IWUIC

2024 GROUP A PROPOSED CHANGES TO THE I-CODES

April 7 – 16, 2024
Doubletree by Hilton
Universal Orlando - Orlando, FL

Figure 1. Detached accessory structures condition in 2024 IWUIC Scope.

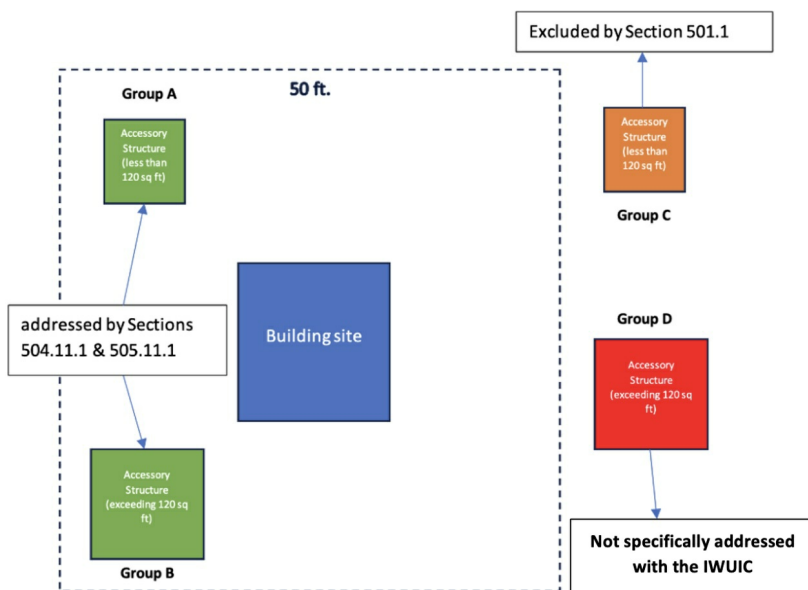
Reason: Based on the current language, detached accessory structures can essentially be categorized into four groups. These groups are illustrated in Figure 1:

- Group A: Detached accessory structures with a floor area of 120 sq ft and less, located less than 50 feet of the primary structure.
- Group B: Detached accessory structures with a floor area greater than 120 sq ft, located less than 50 feet of the primary structure.
- Group C: Detached accessory structures with a floor area of 120 sq ft and less, located 50 feet or more from the primary structure.
- Group D: Detached accessory structures with a floor area greater than 120 sq ft, located at 50 feet or more from the primary structure.

Section 501.1 exempts Group C from the IWUIC, but all other structures must comply with the IBC and the IWUIC. Furthermore, Sections 504.11 and 505.11 of the IWUIC specifically address Group A and Group B detached accessory structures. Sections 504.11 and 505.11 require exterior walls of detached accessory structures located less than 50 feet from a building containing habitable space to be constructed consistent with the required construction of the exterior walls of primary structure. Group D (located 50 feet or more from the primary building and a floor area exceeding 120 square feet) is not specifically addressed by the IWUIC. The lack of specificity could lead to uncertainty regarding the construction of Group D detached accessory structures. A strict reading of the charging paragraph of Section

To address this issue, the proposed language recommends exempting all detached accessory structures located more than 50 feet away from a habitable building from the scope of IWUIC. This suggestion is supported by the findings of structure separation experiments conducted by the IBHS and NIST. These experiments indicate that when the separation distance between structures exceeds 50 feet, the risk of conflagration and structure ignition is significantly lower [1-3]. Chapter 7A of the California Building Code also includes similar requirements in Section 710A.3 (Figure 3) and this change will align these two codes from this perspective [4].

Figure 2. a. 1-hour fire resistance rated exterior wall with OSB sheathing panel on the exterior side [1].

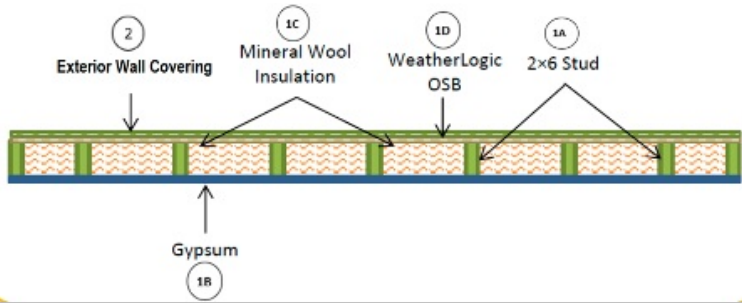
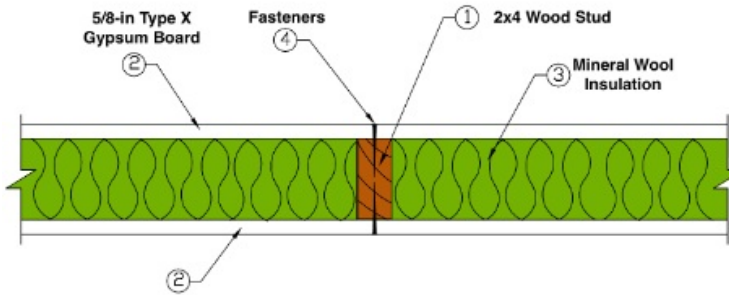
Another concern with 1-hour FRR alone is the wide range of wall assemblies that can meet the performance requirements of ASTM E119. Figure 2 shows two different wall assemblies that achieve 1-hr FRR from either side.

While Figure 2a and 2b both qualify as 1-hr FRR construction, the assembly in Figure 2a is particularly vulnerable to wildfire exposure at the base because combustible sheathing material is used in the assembly. Figure 3 shows a series of fire tests conducted at the IBHS Research Center where different configurations of 1-hour fire-resistant rated assembly with combustible engineered wood siding material were exposed to a small fire at the base. Figure 3a is about a typical 1-hour fire-resistant rated assembly constructed with OSB sheathing material. In this test the OSB sheathing material is exposed from bottom. During this experiment, the fire spread across the surface of the combustible exterior siding and impinged inside the wall cavity because of the exposed bottom surface of OSB sheathing material. Figure 3b shows a 1-hour fire-resistant rated assembly constructed with noncombustible sheathing material in accordance with Figure 2b. In this experiment the fire only ignited the combustible engineered wood siding material and did not impinge inside the wall assembly.

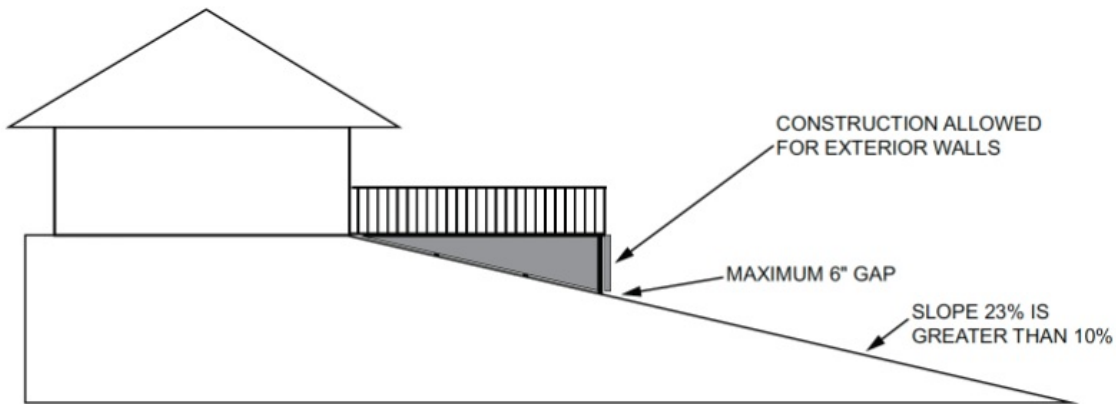
506.6 Appendages and projections. The underfloor areas of unenclosed accessory structures and projections, such as decks, balconies, porches, and stairs attached to buildings with habitable spaces shall be constructed in accordance with Section 506.6.1

506.6.1 Underfloor areas. Unenclosed accessory structures and projections attached to buildings with habitable spaces shall have underfloor areas enclosed to the ground with noncombustible corrosion-resistant mesh with openings not to exceed 1/8 inch (3.2 mm).

Exception: Complete enclosure shall not be required where a minimum of 6 inches of metal flashing or noncombustible material applied vertically on the exterior of columns and supporting walls at the ground.

FIGURE 603.2 MEASUREMENTS OF FUEL MODIFICATION DISTANCE

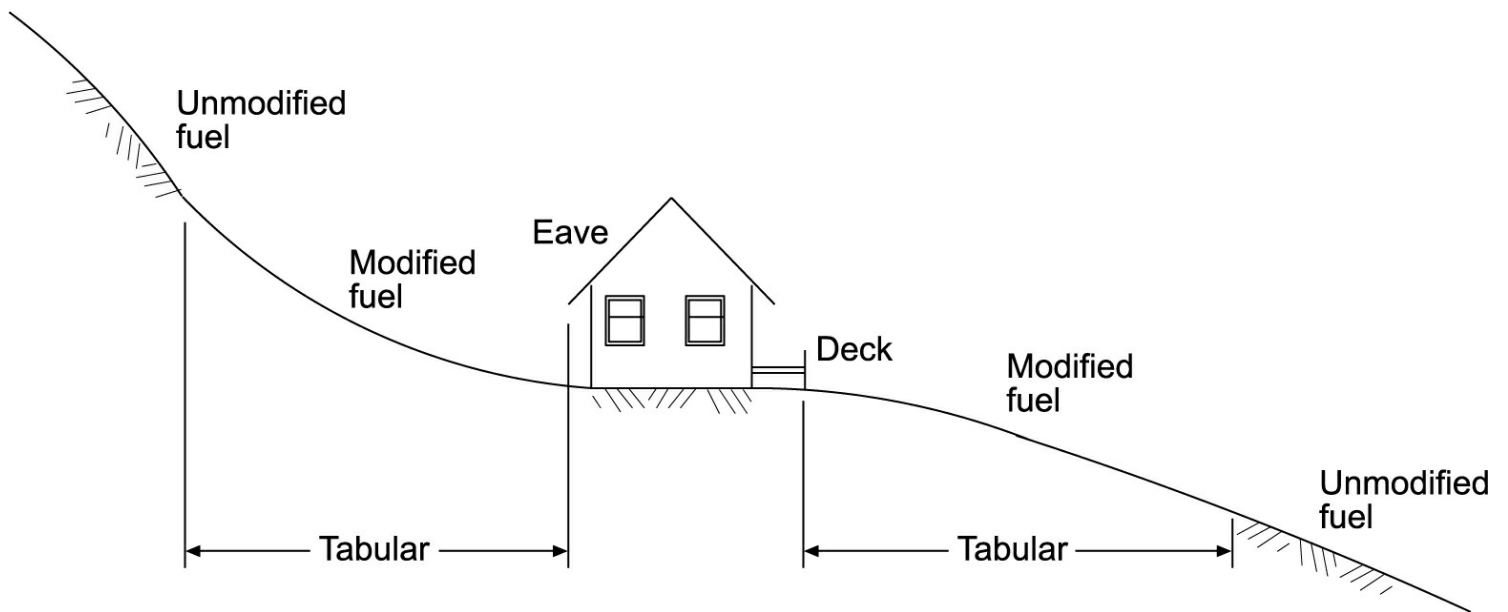
Buildings or structures, constructed in compliance with the conforming *defensible space* category of Table 503.1, shall comply with the *fuel modification* distances contained in Table 603.2. For all other purposes the *fuel modification* distance shall be not less than 30 feet (9144 mm) or to the lot line, whichever is less. Distances specified in Table 603.2 shall be measured on a horizontal plane from the perimeter or projection of the building or structure as shown in Figure 603.2. Distances specified in Table 603.2 are allowed to be increased by the *code official* because of a site specific analysis based on local conditions and the *fire protection plan*.
